Addendum #2 – Issued December 3, 2012

Regarding Bids for **Engineer Road Maintenance Building – MEP, Fire Protection, General Trades & Fueling System (ITB 12-032P)** for Lucas County Engineer Road Maintenance, bid opening scheduled for December 6, 2012 at 2:00 P.M. (local time).

ADDENDUM NO. 02

Lucas County Road Maintenance Building
Bid Package #12-032P – Plumbing, Mechanical, Electrical, Fire Protection,
General Trades and Fueling Station Packages
Dated 12/3/2012

OVERALL FIRST FLOOR PLAN – PLUMBING – UNDERGROUND

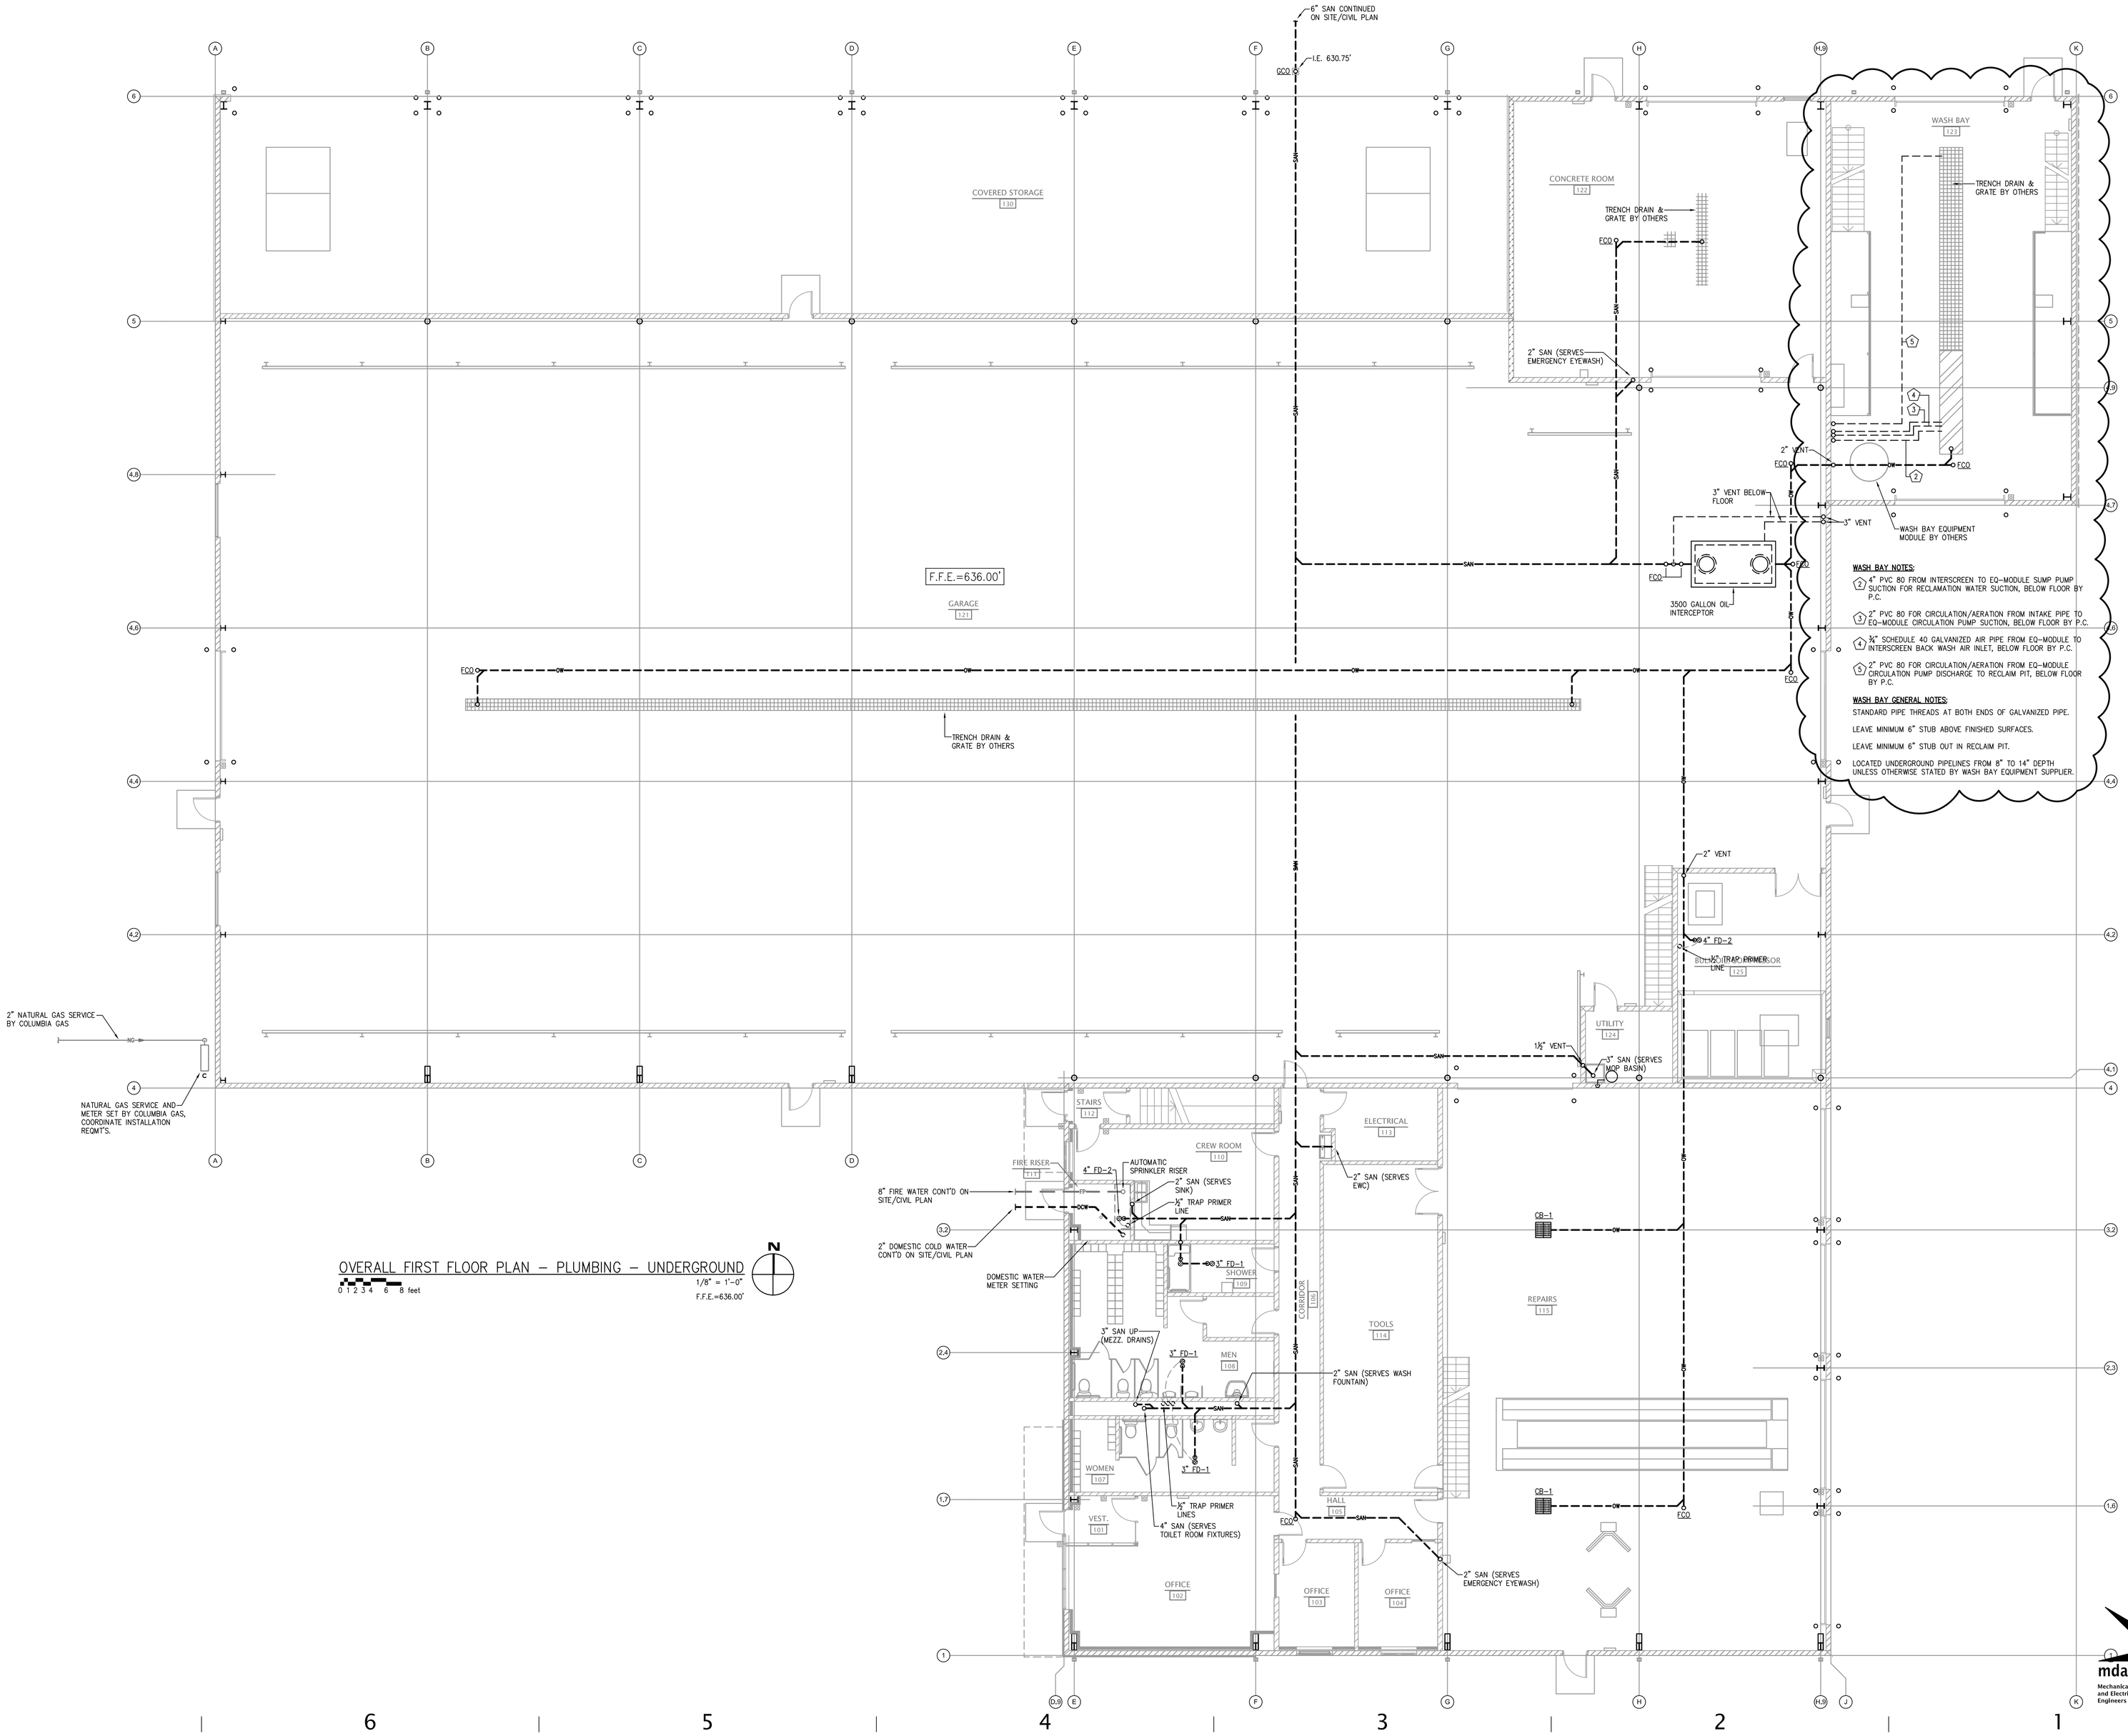
Drawing P1.01 First Floor Plan – Plumbing – Underground (drawing reissued):
Item #1 Add Wash Bay underground piping and notes.
